CONTRACT CHANGE ORDER NO. 217S2
SHEET 2 OF 5

MARK	DATE	DESCRIPTIONS	BY	CH'D	CCO#
7	09/06/13	SKYWAY BIKEPATH HINGE	AB	TH	217S2
6	12/09/11	BIKEPATH HANDRAIL MODIFICATIONS	DT	JD	169
5	04/01/11	BIKEPATH CONDUIT	TH	JD	73
4	08/20/10	BIKEPATH DETAILS	TH	CC	99
3	04/22/09	BIKEPATH DETAILS	TH	MN	99
2	01/30/09	BIKEPATH DETAILS	TH	MN	99
1	11/26/08	BIKEPATH DETAILS	TH	MN	99

SAN FRANCISCO OAKLAND BAY BRIDGE
EAST SPAN SEISMIC SAFETY PROJECT
SELF-ANCHORED SUSPENSION BRIDGE
(SUPERSTRUCTURE & TOWER)

RAILING DETAILS NO. 3

HINGE A
RAILING EXPANSION JOINT DETAILS
1:20

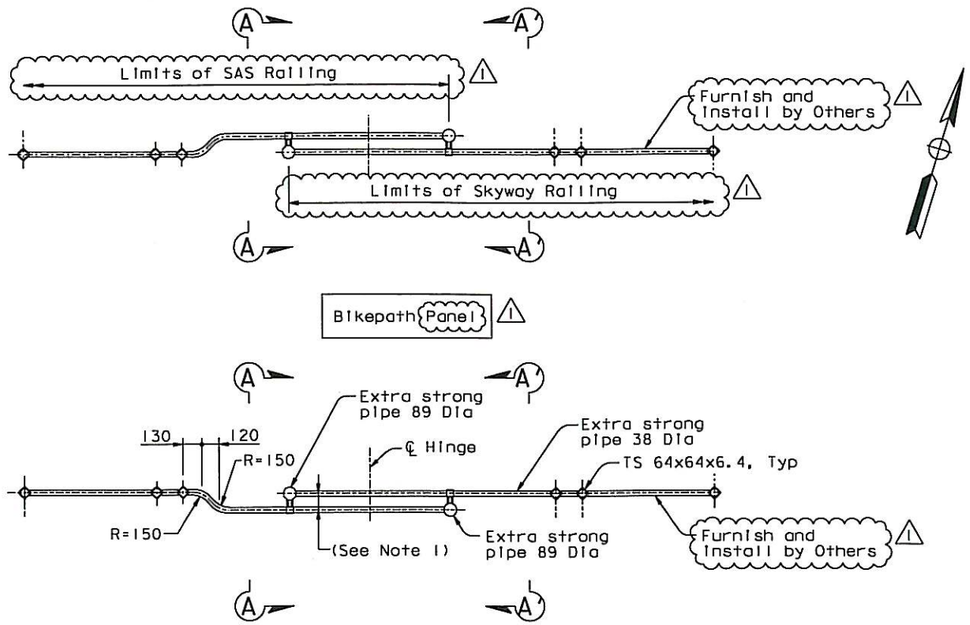
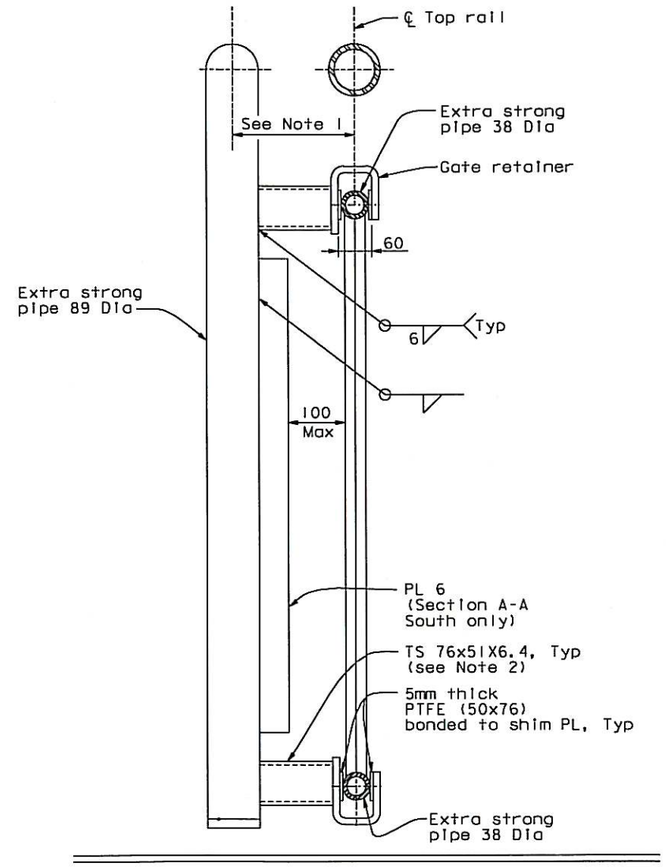
MARK	DATE	DESCRIPTIONS	BY	CH'D	CCO#
1	09/17/13	SKYWAY BIKEPATH HINGE	AB	TH	217S2
0	09/06/13	SKYWAY BIKEPATH HINGE	AB	TH	217S2

1. Spacing for south railing posts shall be determined by the Engineer following railing alignment adjustment by the Contractor. North railing posts shall be left in their natural position prior to welding gate retainer to the fixed railing.
2. Location and length of TS 76x51 shall be determined by field measurements. Extension plates may be required.

SKYWAY BIKEPATH EXPANSION JOINT REPLACEMENT NO. 3

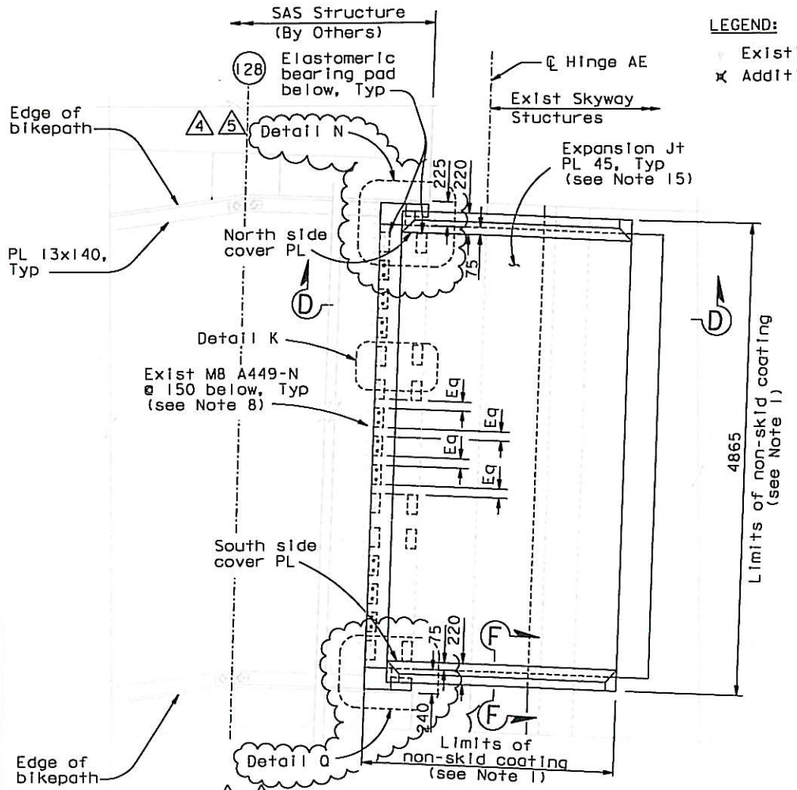
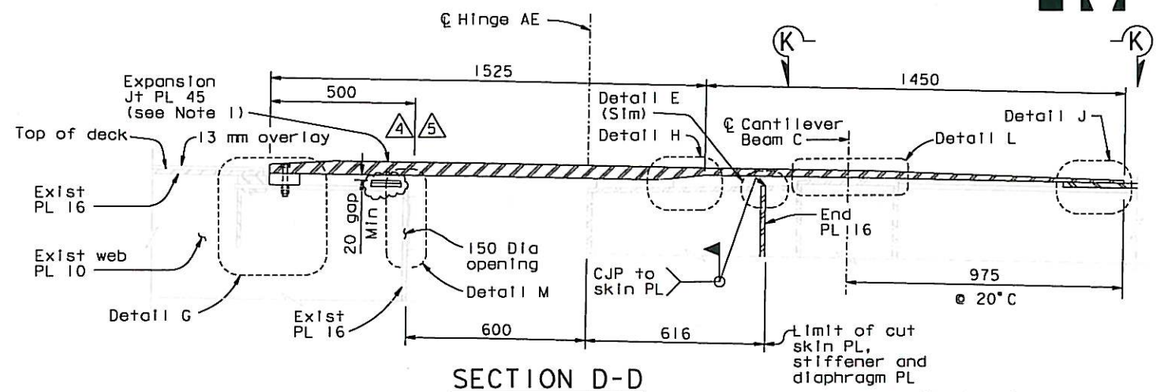
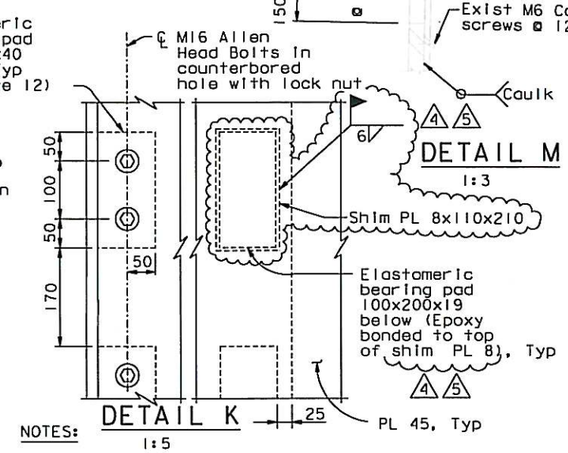
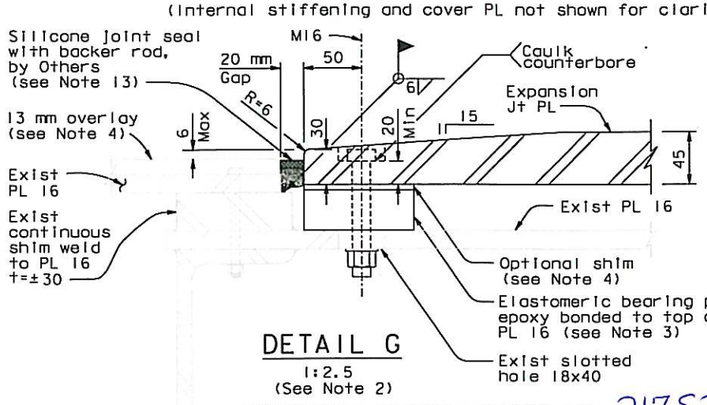
MARK	DATE	DESCRIPTIONS	BY	CH'D	CCO#
5	03/25/14	SKYWAY BIKEPATH HINGE	AB	AS	217S2
4	08/28/13	SKYWAY BIKEPATH HINGE	DT	AS	217S2
3	01/18/13	SKYWAY NON-SKID	JD	AS	217S1
2	10/04/12	SKYWAY NON-SKID	JD	AS	217S1
1	03/13/12	SKYWAY BIKEPATH HINGE	CC	AS	217S1
0	04/15/11	SKYWAY BIKEPATH EXPANSION JOINT	AS	HP	193

NOTES:
1. Top surface of exposed plates shall have non-skid coating, to be performed by Others. The non-skid coating shall match the existing color pattern. Where the tapered edge cover plate extends over the existing white edge of the bikepath panel, white finish paint shall be used in lieu of non-skid.

2. For details not shown, see SAS-"Bikepath Details" sheets.
3. Pre-compress elastomeric pad by 2 mm by means of 1 turn of M16 bolt.
4. Thickness of shim and overlay may vary to provide tolerance to adjust for As-Built Skyway.

5. NOTE DELETED
6. Slope shall match the slope of exist top PL of Cantilever Beam C.
7. The Contractor shall verify all the dimensions in field before fabricating the expansion joint plate. All the plates cut shall be ground square.

8. Bolts shall be installed with threads including in the shear plane.
9. NOTE DELETED
10. For Detail E, see "Skyway Bikepath Expansion Joint Replacement No. 1" sheet.

11. For Section K-K, see "Skyway Bikepath Expansion Joint Replacement No. 3A" sheet.
12. Thickness of elastomeric bearing pad is for information only. Contractor to field verify required thickness.

13. Top of silicone joint seal shall be no more than 6 mm lower than top of expansion Jt PL.
14. Expansion plate shall be fabricated to fit the as-built Skyway and SAS Bikepaths. Expansion plate shall be bent at the centerline of cantilever beam C or cambered.

15. At the Contractor's option, expansion Jt PL 45 may be fabricated with up to 2 longitudinal joints. Longitudinal joints shall be welded with a 10 PJP, top and bottom.

16. Side cover PL 16 shall follow profile of expansion Jt PL 45.
17. For Details N and Q, see "Skyway Bikepath Expansion Joint Replacement No. 3A" sheet.

SKYWAY BIKEPATH EXPANSION JOINT REPLACEMENT NO. 3A

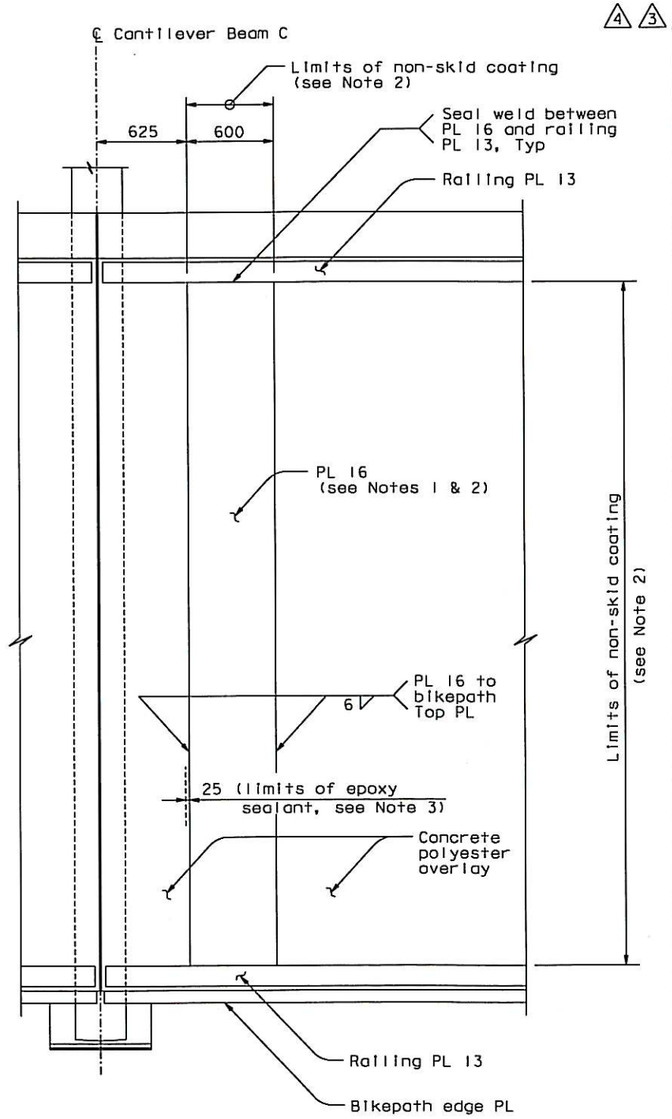
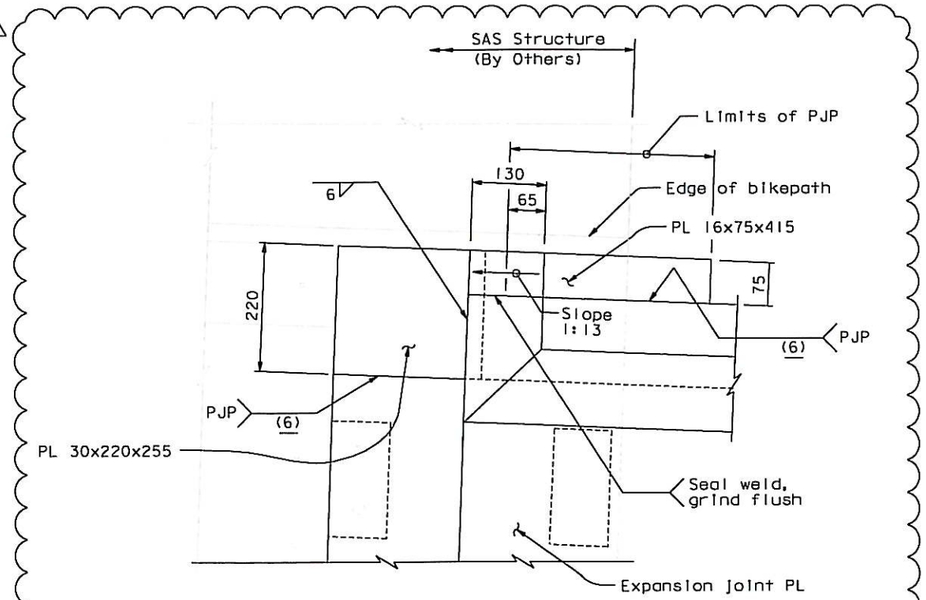
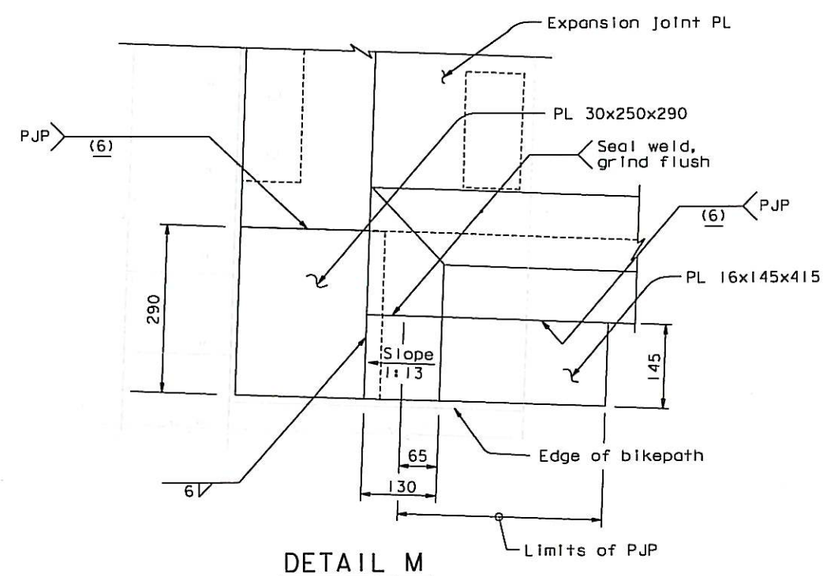
MARK	DATE	DESCRIPTIONS	BY	CH'D	CCO#
4	03/25/14	SKYWAY BIKEPATH HINGE	AB	AS	217S2
3	08/28/13	SKYWAY BIKEPATH HINGE	DT	AS	217S2
2	01/18/13	SKYWAY NON-SKID	JD	AS	217S1
1	10/04/12	SKYWAY NON-SKID	JD	AS	217S1
0	03/13/12	SKYWAY BIKEPATH HINGE	CC	AS	217S1

1. Remove concrete polyester overlay before placing PL 16. Polyester overlay in the vicinity of PL 16 shall be replaced / repaired as needed.
2. Top surface of PL 16 not covered by expansion joint plate shall have non-skid coating, to be performed by Others.
   The non-skid coating shall match the existing color pattern. Where the tapered edge cover plate extends over the existing white edge of the bikepath panel, white finish paint shall be used in lieu of non-skid.
3. At the Contractor's option, 25 mm of the replaced/repaired concrete polyester overlay may be substituted with epoxy sealant.
4. At the Contractor's option, 1¼" thick plate may be used in lieu of PL 30.
5. At the Contractor's option, ⅝" thick plate may be used in lieu of PL 16.
6. At the Contractor's option, the PL 16 and PL 30 may be ASTM A36 steel.
